Evaluation Kit for RA8E2 Microcontroller Group  
EK-RA8E2 v1  
Errata

Renesas RA Family  
RA8 Series

EK-RA8E2 v1 – Errata

Figure 1. Crystal Oscillator with incorrect load capacitance

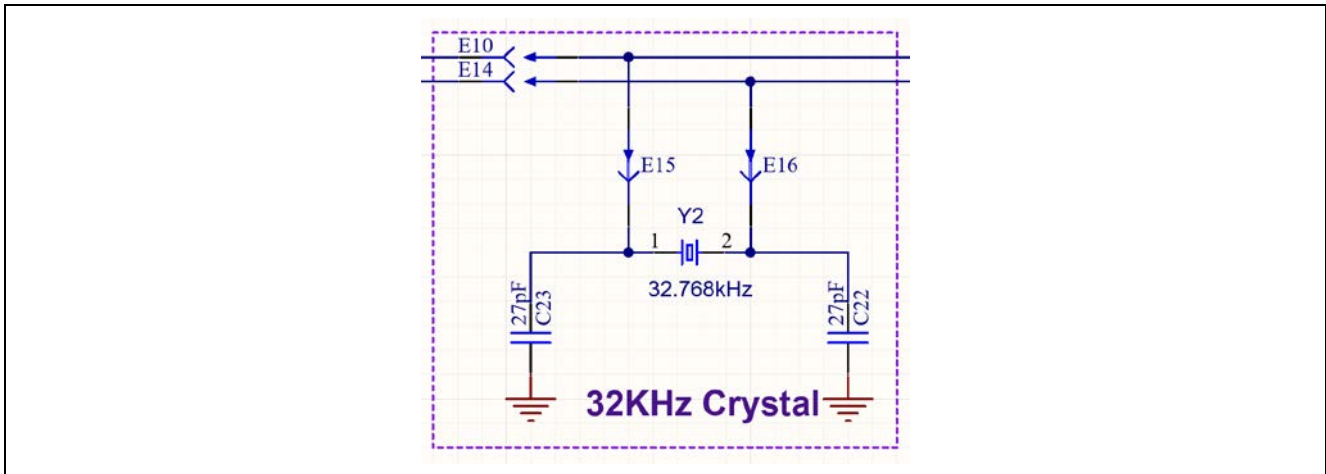
Due to incorrectly specified crystal load capacitance and capacitors C22 and C23, the RTC can be inaccurate in the order of 10 seconds every 24 hours. This is because the fitted crystal ABS07-32.768KHZ-9-T requires a 9pF load capacitance  $C_L$ , given by the formula  $C22=C23=2*(C_L-C_{stray})$ , and so the load capacitors C22 and C23 should be significantly lower than the fitted 27pF capacitors.

To address this the user can replace the load capacitors, C22/C23, with 10pF parts, for example GRT1555C2A100JA02D. This value has been tested and found to be appropriate for the device and board configuration.
